**Watts Bar Nuclear Plant  
Rhea County, Tennessee**

EVALUATION OF SONIC  
VELOCITIES IN LOWER  
COMPARTMENT

Supplement No. 1 to the staff's safety evaluation for the Watts Bar Nuclear Plant recommends: "To allow further margin for uncertainties in describing the transient flow characteristics of the steam-air water mixtures that flow past major flow obstruction (e.g., steam generators) or through the major relief paths from a subvolume or subcompartment, it is recommended that mixture flow velocities projected to occur in these restricted flow regions be maintained at levels less than approximately three-fourths of the sonic velocity for the flowing mixture." This report addresses the recommendation by describing the location and time duration for which sonic flow exists in the present design, and explaining why sonic flows are acceptable, and, therefore, not necessary to comply with the staff's 75 percent of sonic velocity recommendation. Essentially, it is shown that flow choking does not represent a threshold beyond which sharper increase in compartment pressure could be expected.

FIGURE 6 DETERMINATION OF MASS FLUX CORRESPONDING TO 75 PERCENT OF SONIC VELOCITY (ILLUSTRATIVE)

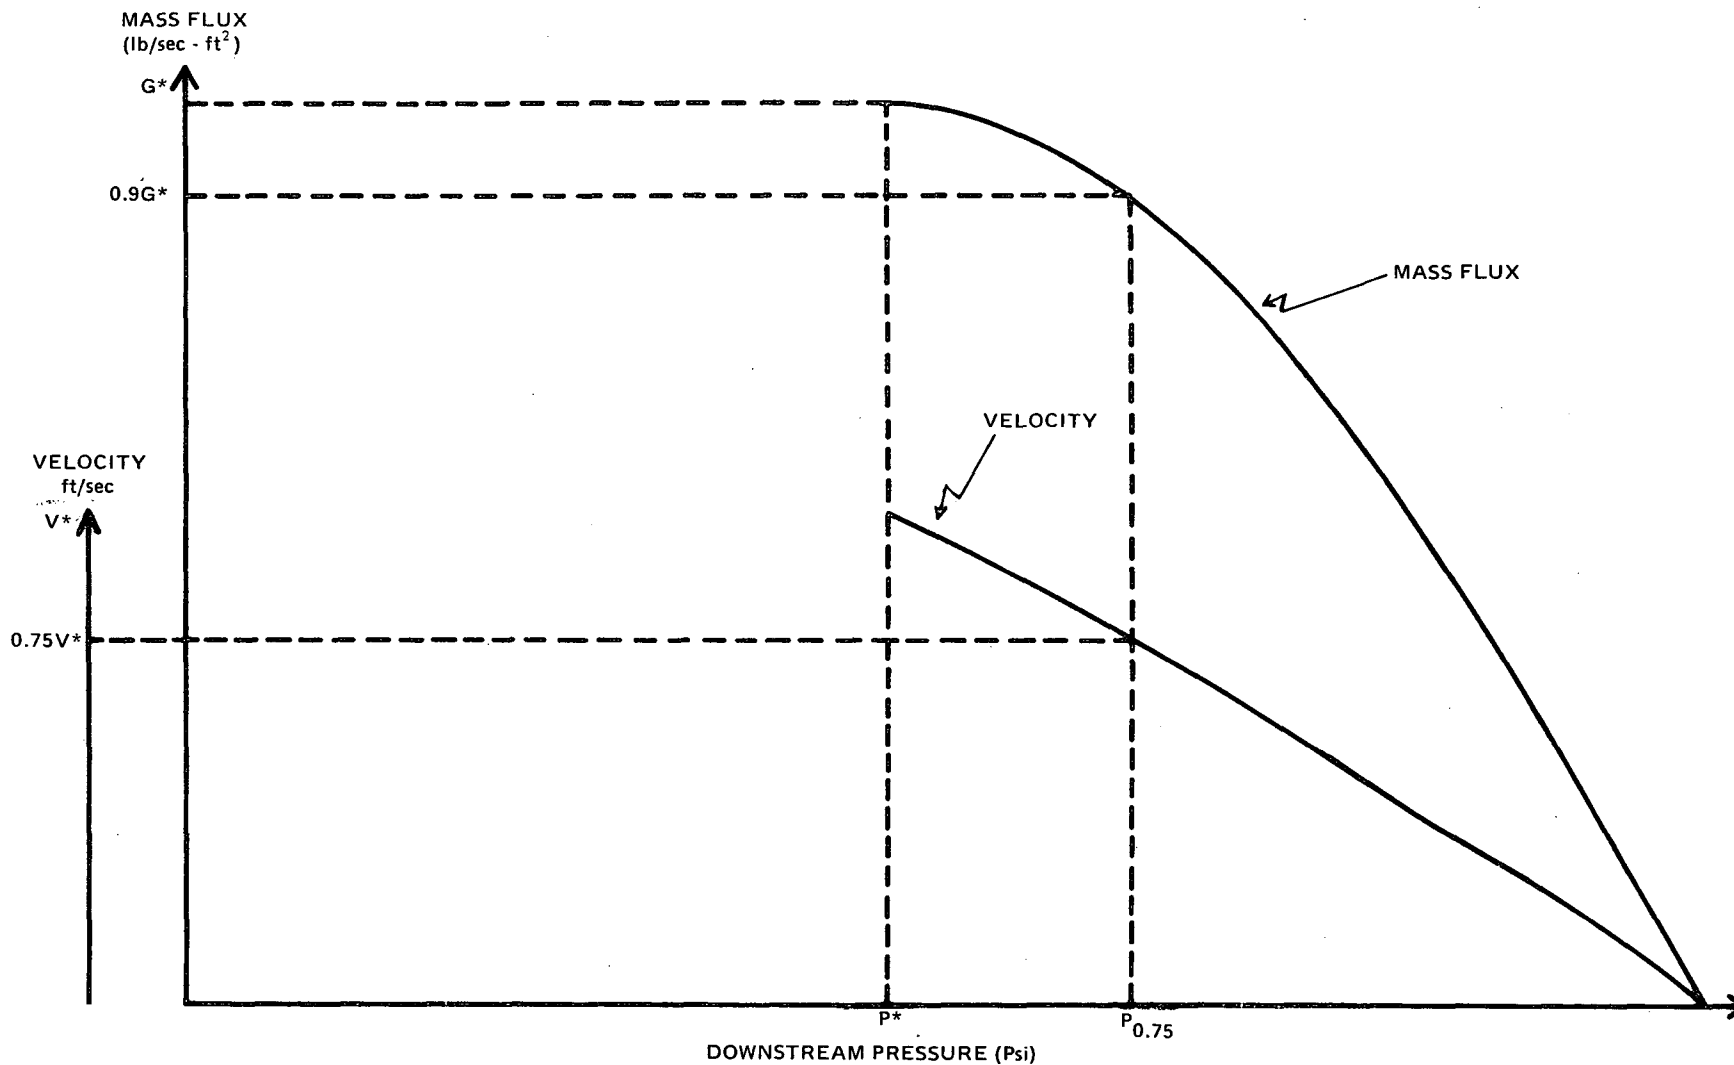
For this evaluation, then, a special TMD run was made to define a 75 percent sonic condition in terms of critical mass flux. The procedure used was as follows (see figure 6). For a given set of upstream conditions, critical mass flux was calculated using the existing TMD critical flow routine. This value of critical mass flux defined sonic velocity ( $V^*$ ) for the flow path in question under these conditions. Further iterations were then made to search for the value of downstream pressure that would establish a fluid velocity which was 75 percent of this sonic value. With a downstream pressure established, mass flux through the flow path was then calculated. This mass flux would correspond to a 75 percent sonic condition. Results of the analysis for a range of upstream conditions indicate a mass flux of approximately 90 percent of the critical mass flux which is representative of a 75 percent sonic condition. That is:

$$\frac{G}{G^*} = 0.9 \text{ for 75 percent sonic conditions}$$

FIGURE 7 CRITICAL MASS FLUX RATIO PAST STEAM GENERATORS VS TIME

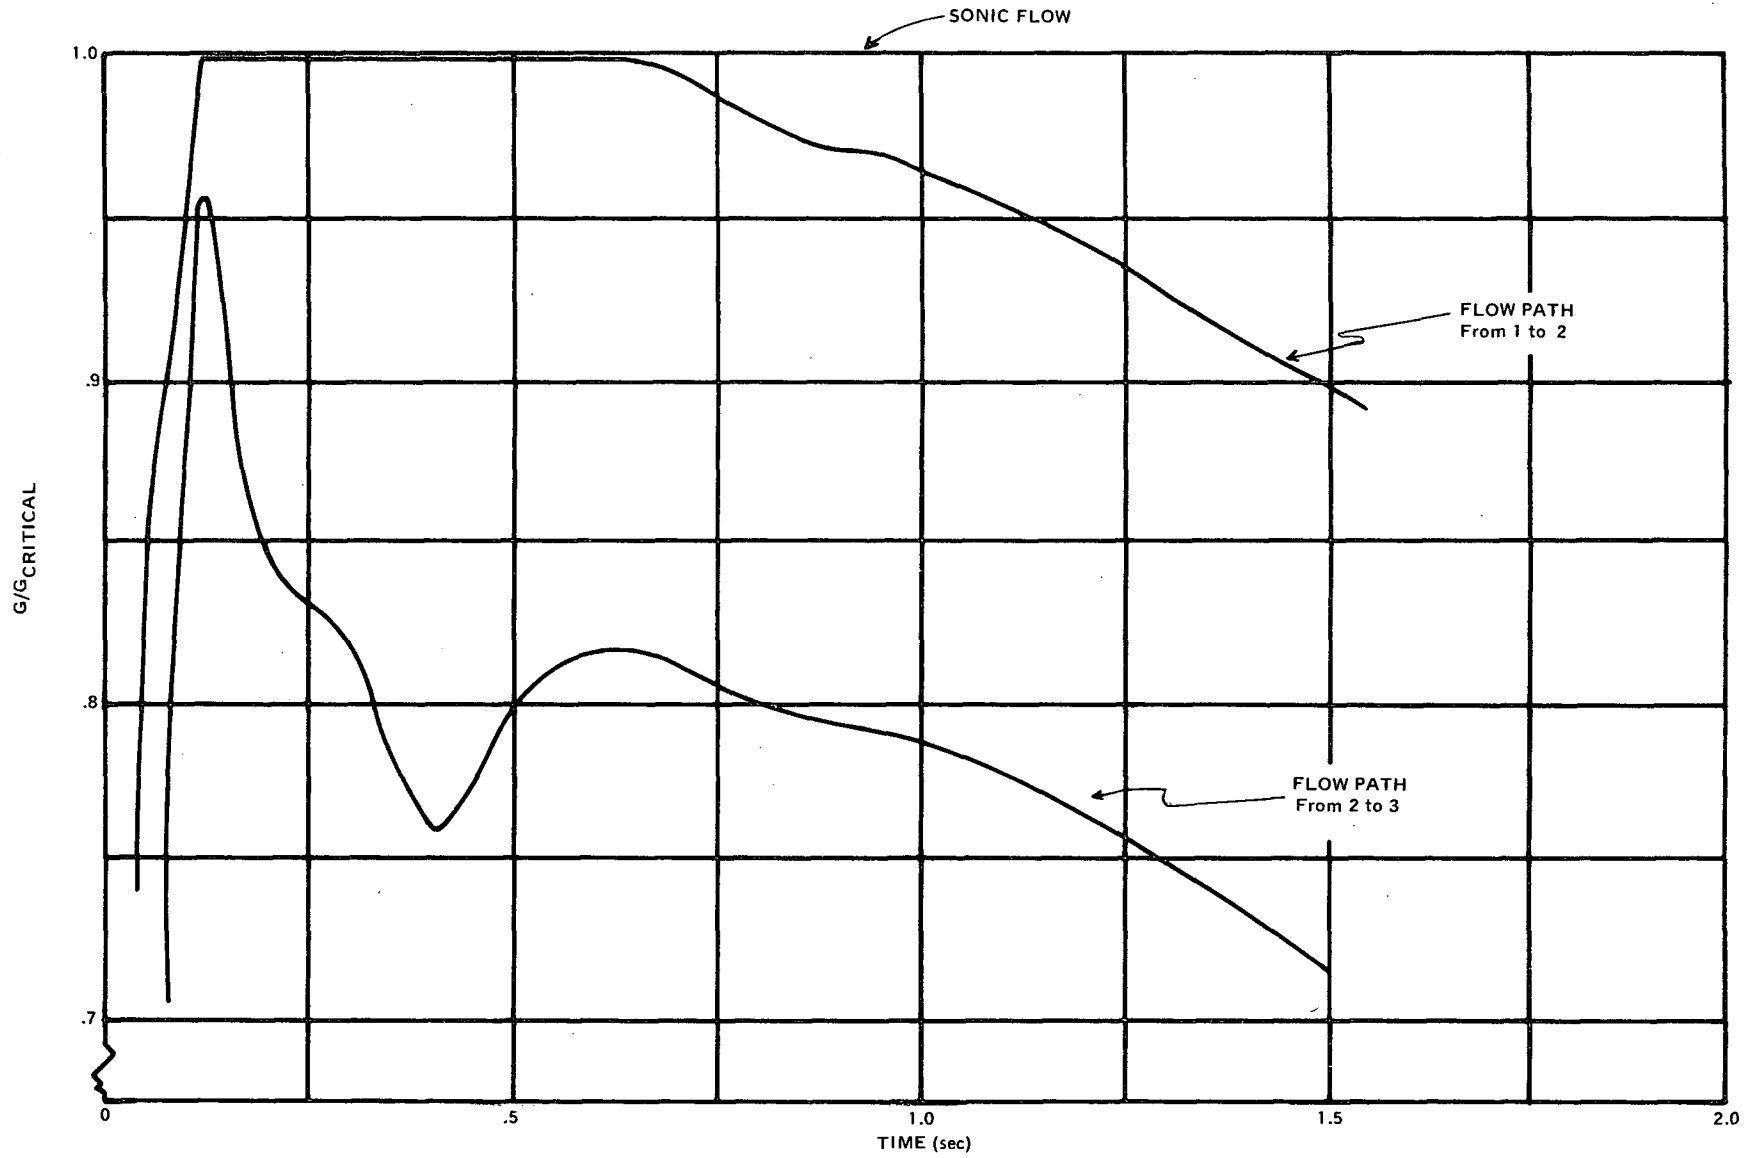
The break considered, which gives the worst flow condition because of the longer sustained blowdown rate, is the DECL break in compartment 1. Results of this analysis, which used the present Watts Bar plant geometry, show flow choking to occur for approximately 0.5 second past the first two

steam generators. In addition, for 1.5 seconds, some flow paths remain at 90 percent of the critical mass flow which corresponds to a maximum velocity of approximately 75 percent of sonic velocity. Figure 7 shows the critical mass flux ratio versus time for the major vent area (past the steam generator) where flow choking occurs. Flow choking past other steam generators and pressurizer does not occur.

FIGURE 8 ILLUSTRATION OF CHOKED FLOW CHARACTERISTICS

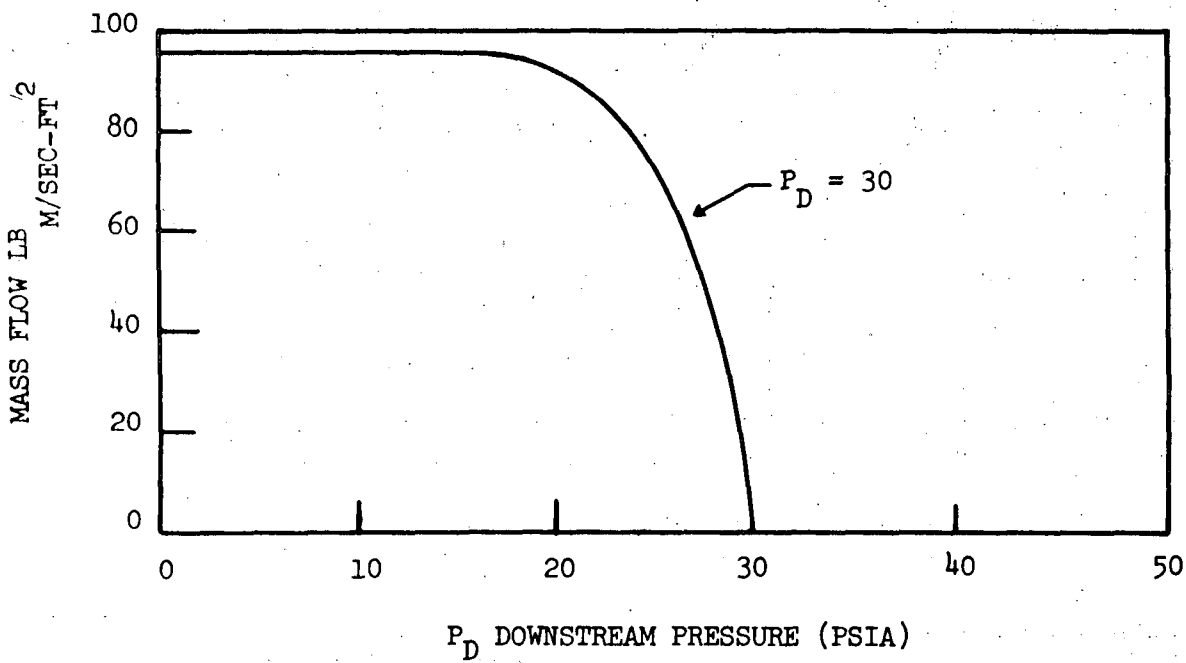
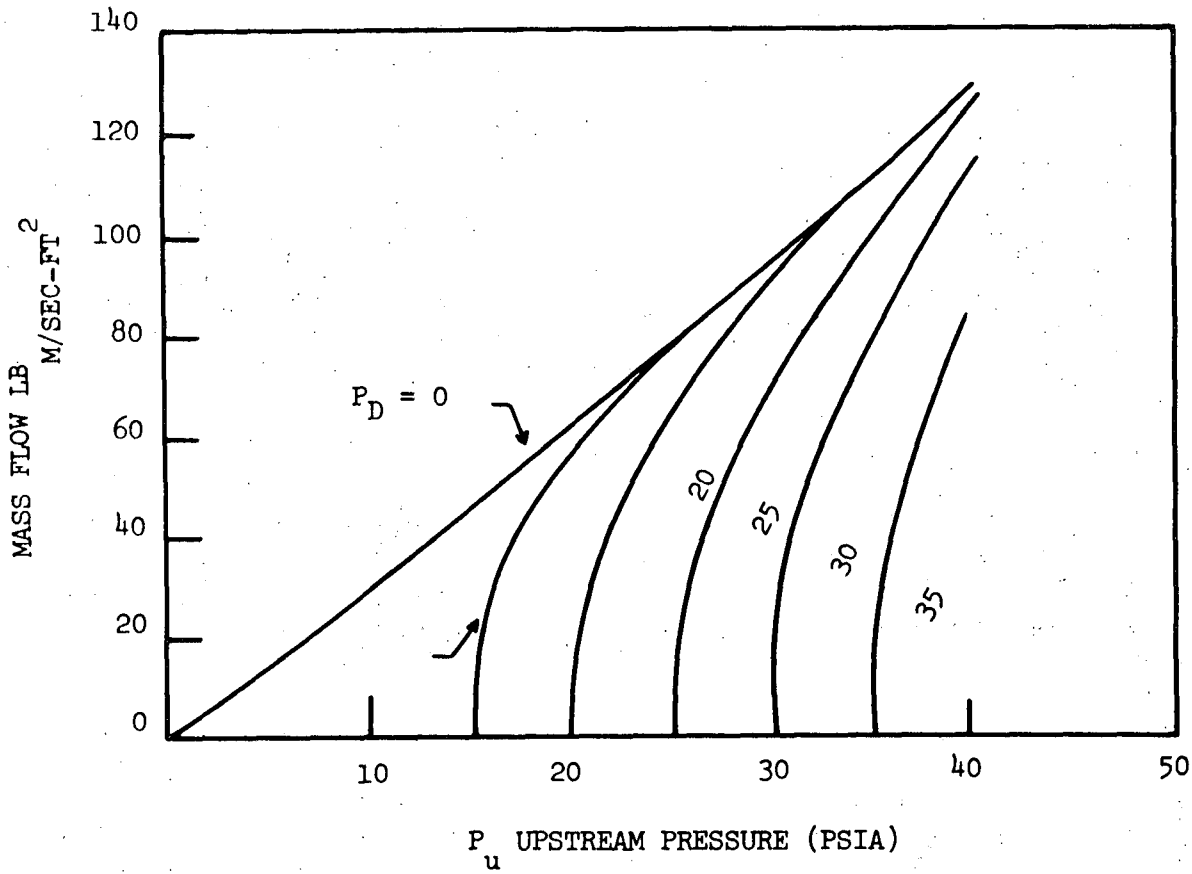
The phenomenon of flow choking is frequently explained by assuming a fixed upstream pressure and examining the dependence of flow rate with respect to decreasing downstream pressure. This approach is illustrated for an assumed upstream pressure of 30 psia as shown in the upper plot of figure 8 with the results plotted versus downstream pressure in the lower plot of figure 8. For fixed upstream conditions, flow choking represents an upper limit flow rate beyond which further decreases in back pressure will not produce any increase in mass flow rate. The data in figure 8 illustrates the behavior of mass flow rate as a function of upstream and downstream pressures, including the effects of flow choking. The upper plot shows mass flow rate as a function of upstream pressure for various assumed values of downstream pressure. For zero back pressure ( $P_d = 0$ ), the entire curve represents choked flow conditions with the flow rate approximately proportional to upstream pressure,  $P_u$ . For higher back pressure, the flow rates are lower until the upstream pressure is high enough to provide choked flow. After the increase in upstream pressure is sufficient to provide flow choking, further increases in upstream pressure cause increases in mass flow rate along the curve for  $P_d = 0$ . The key point in this illustration is that flow rate continues to increase with increasing upstream pressure, even after flow choking conditions have been reached. Thus, choking does not represent a threshold beyond which dramatically sharper increases in compartment pressure could be expected because of limitations on flow relief to adjacent compartments.

FIGURE 9 COMPARTMENT PEAK PRESSURE FOR DECL BREAK  
IN COMPARTMENT I VS % DBA

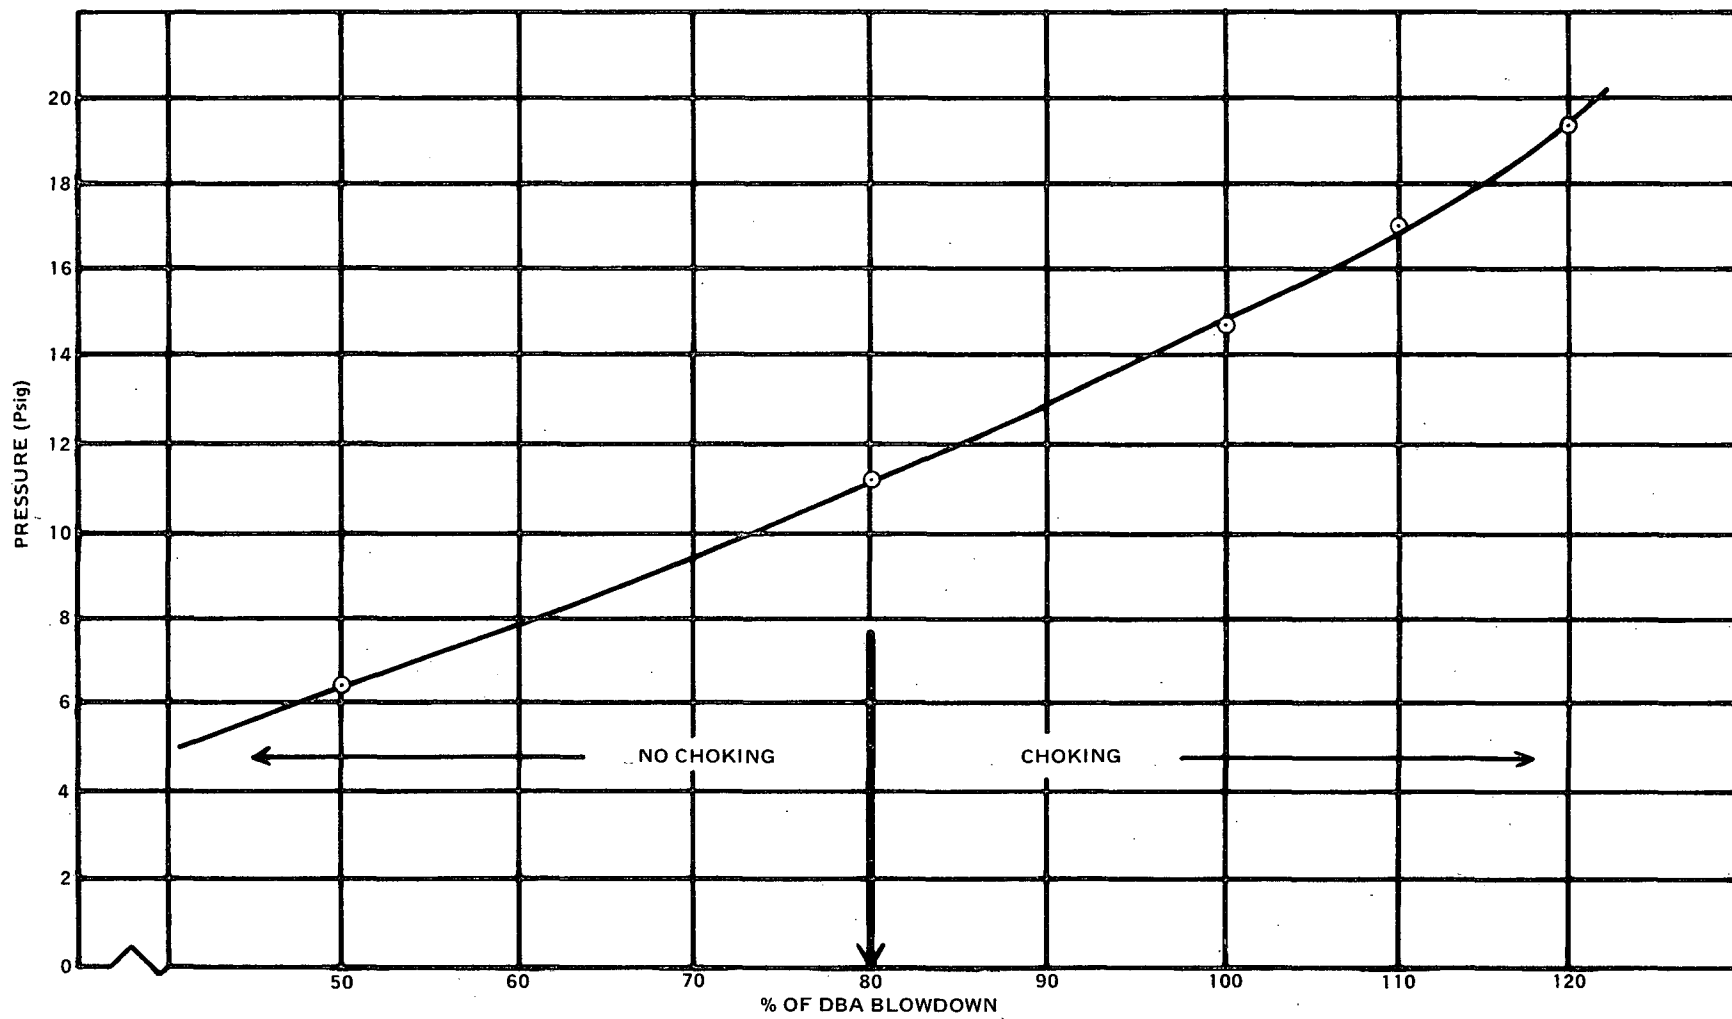
To demonstrate the flow choking effect on peak pressure in the actual plant, sensitivity runs were made on the blowdown rate for the present Watts Bar geometry. Blowdown rates from 50 to 120 percent of the double-

ended cold leg were studied for the worst break location. Blowdown rates 80 percent and higher produced choking past major flow areas of the lower compartment. Below this blowdown rate, no flow choking occurred. Figure 9 is a plot of peak break compartment pressure versus blowdown rate. As can be seen from this curve, the rate of pressure rise is essentially linear before and after flow choking occurs.

In summary, it has been shown that even though velocities in the present Watts Bar design exceed the staff's 75 percent of sonic velocity recommendation, this is of no consequence since flow choking in major vent areas does not represent a threshold in the rate of pressure increase.
